**Subject: Correct and Complete Application for Beneficial Water Use Permit No. 76LJ 30171747**

RE: GW Permit Application 76LJ 30171747  
RJM Properties LLC, 1191 Majestic View Ln.  
in Section 17, Township 27 North, Range 20 West, Flathead County, Montana

A deficiency letter was received from DNRC regarding the application for beneficial water use permit (76LJ 30171747) on October 21, 2025. Responses are provided below for clarification.

Figure 1. Vicinity Map

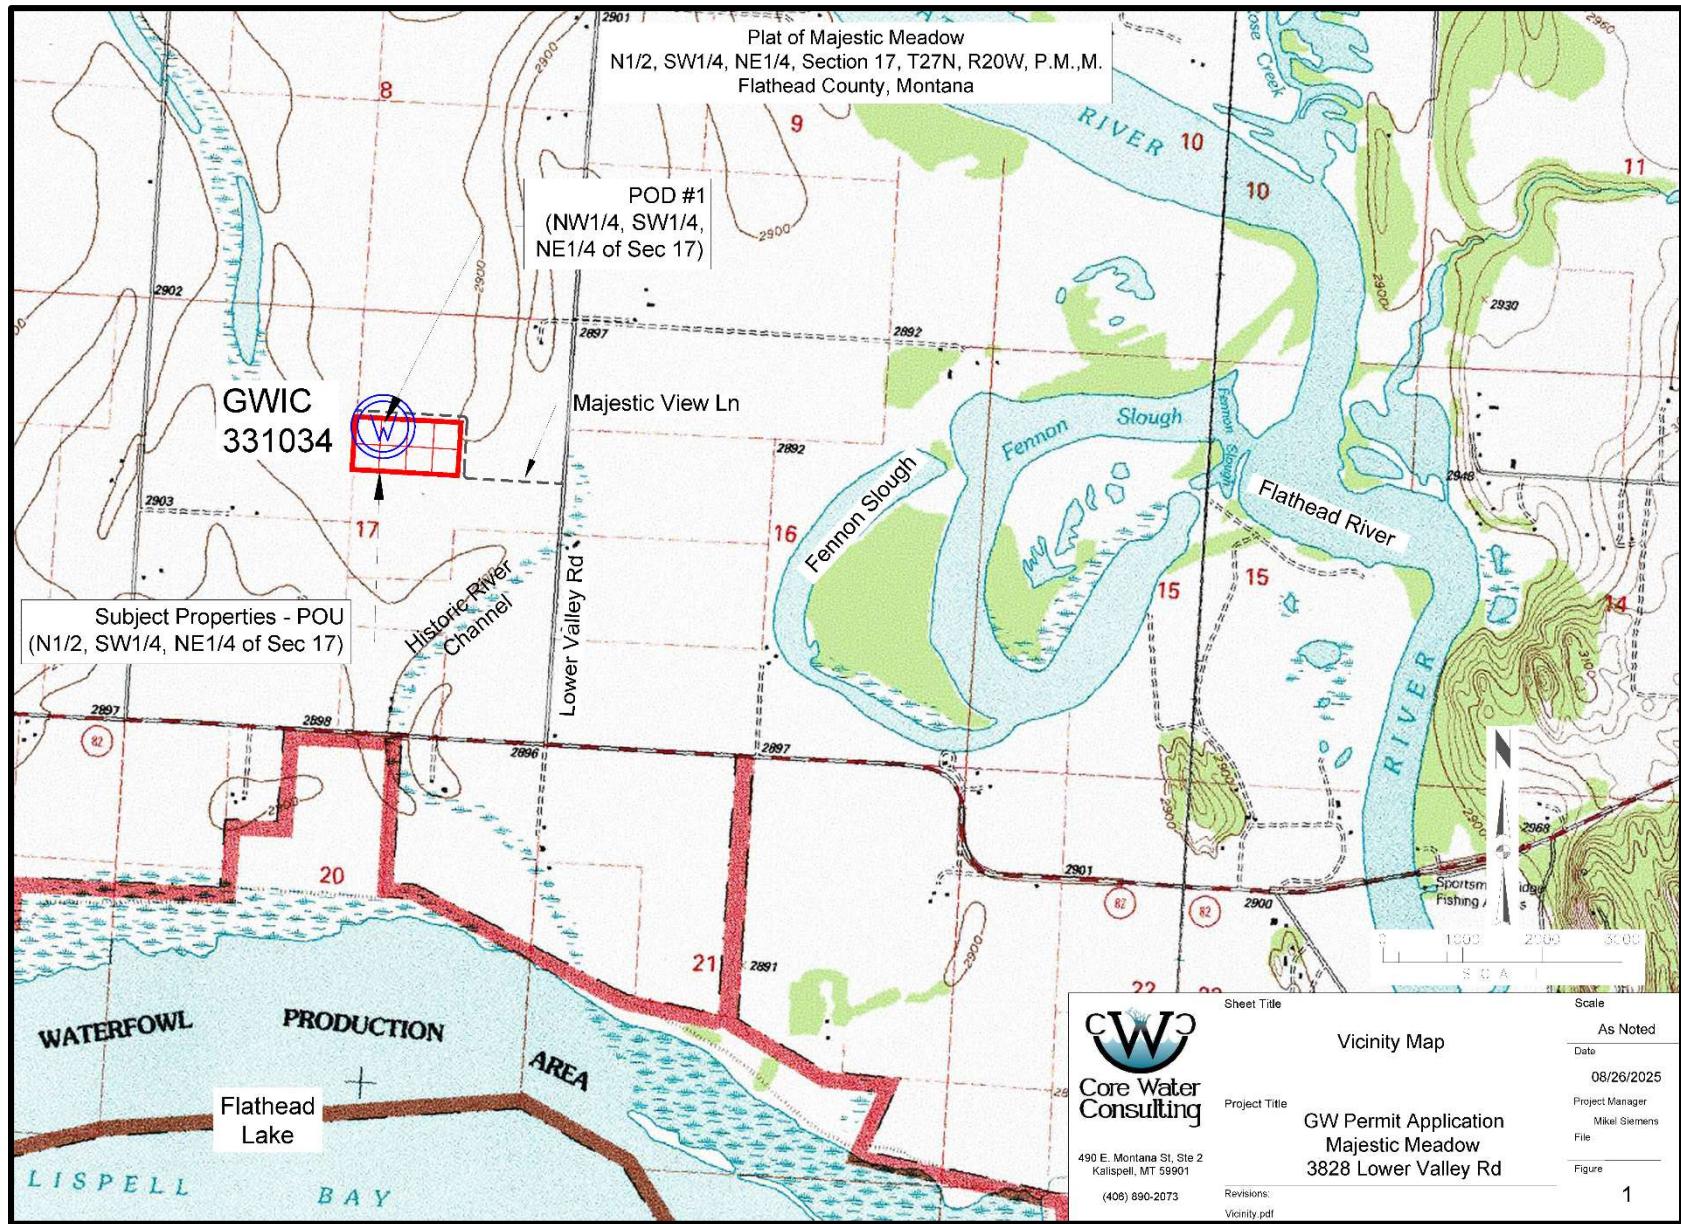
*1. Form 600 – Question 20 and Supplemental Report Pg 2*

*Q20: Describe the proposed location of the point(s) diversion to the nearest ¼ ¼ ¼ Section. Label each POD with the POD ID number used on the project map (question 17).*

Response: The POD is in the NW1/4, SW1/4, NE1/4 of Section 17, T27N, R20W. The location information on page 2 of the supplemental was incorrect. The POD is located on Lot 2 of the subdivision. The correct POD is identified on Figure 1 Vicinity Map (attached). Thank you for noticing the discrepancy.

## Page 4 of Form 600

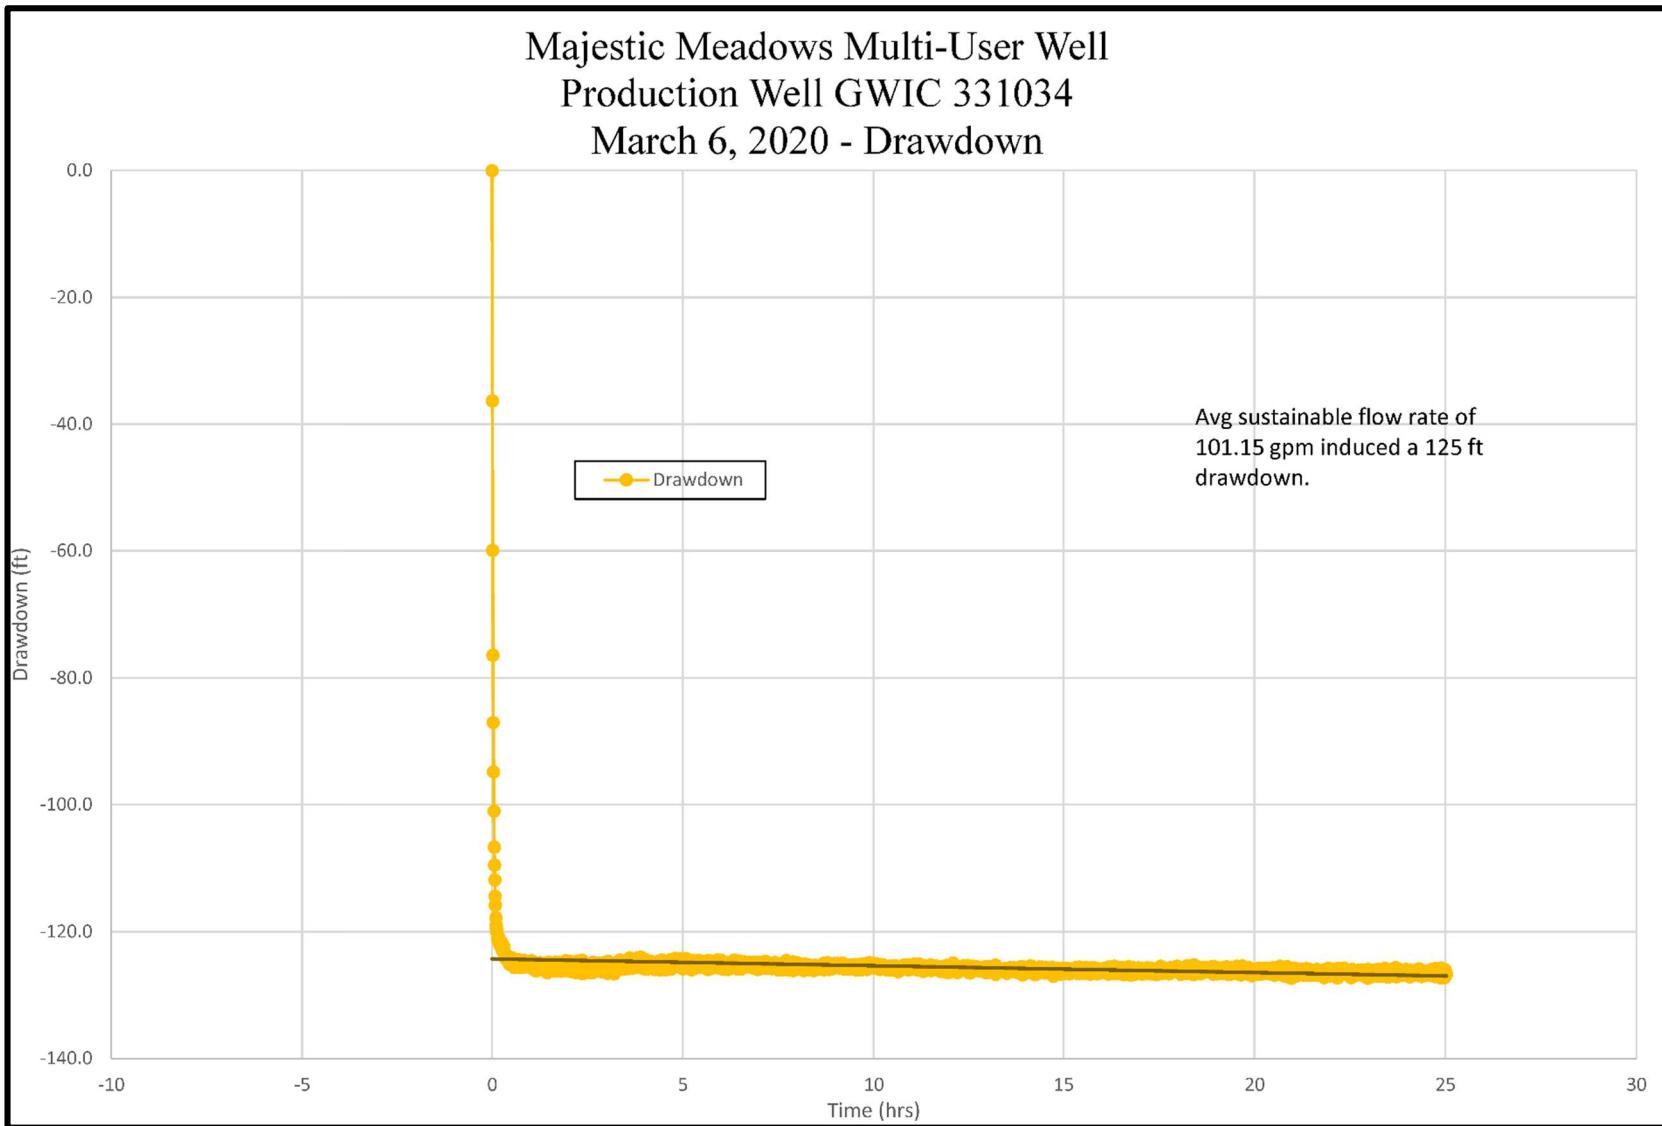
*3. Form 600 – Question 18 and Supplemental Report*

*1. The response on the application was requesting 2.24 AF for multiple domestic, 19.48 AF for lawn and garden, with a total requested volume of 21.72 AF. On page one of the supplemental report in the introduction section a volume of 21.63 acre-feet/year (AF/year) was requested.*

*2. Flow rate requested at 105 on the application but the supplemental report states multiple GPM rates:*

Response: The volume listed in the introduction to the supplemental report was incorrect. The total volume of 21.72 AF is requested.

***The volume being requested is 21.72 AF and the flow rate requested is 101.15 gpm.***
